# Access Compliance Report

## Public Rights-of-Way

Intersection ID: 23977	Main Street: REA_RD	Cross Street: WINDYRUSH_RD	Location: NE
ADA ID: 141309E7BF99	Ramp Type: BlendTrans2	Initial Pass/Fail: Fail	Overall Compliance: No
		Severity Score: 1.25

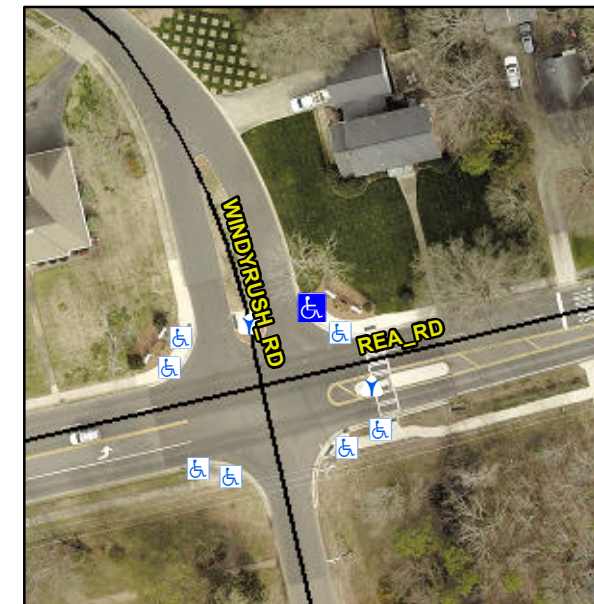
**R304.5.3**

Compliance	Description	Data	Compliance	Description	Data
N/A	Ramp Length (in)	70.0	Yes	BlendTrans Slope (%)	0.4
Yes	Ramp Width (in)	69.0	No	BlendTrans XSlope (%)	2.4
N/A	Flare Type LT	N/A	N/A	Flare Type RT	N/A
N/A	Flare Slope LT (%)	N/A	N/A	Flare Slope RT (%)	N/A
N/A	Flare Traversable LT?	N/A	N/A	Flare Traversable RT?	N/A
N/A	Landing Length (in)	N/A	N/A	DWS Provided?	N/A
N/A	Landing Width (in)	N/A	N/A	DWS Contrast?	N/A
N/A	Landing Slope (%)	N/A	N/A	DWS Length (in)	N/A
N/A	Landing X Slope (%)	N/A	N/A	DWS Full Width?	N/A
N/A	Landing Curb? (Y/N)	N/A	N/A	DWS Offset (in)	N/A
N/A	Shared Landing?	N/A			
N/A	Gutter Ponding?	N/A	N/A	Gutter Slope (%)	N/A
N/A	Gutter Lip Ht (in)	N/A	N/A	Gutter X Slope (%)	N/A
N/A	Painted X Walk1?	No	N/A	Painted X Walk2?	N/A
	X Walk 1 Direction	To W		X Walk 2 Direction	N/A
	X Walk 1 Width (in)	N/A		X Walk 2 Width (in)	N/A
	X Walk 1 Slope (%)	2.1		X Walk 2 Slope (%)	N/A
	X Walk 1 X Slope (%)	1.2		X Walk 2 X Slope (%)	N/A

**Remove & Replace Curb Ramp With Two New Directional Ramps or Equivalent.**
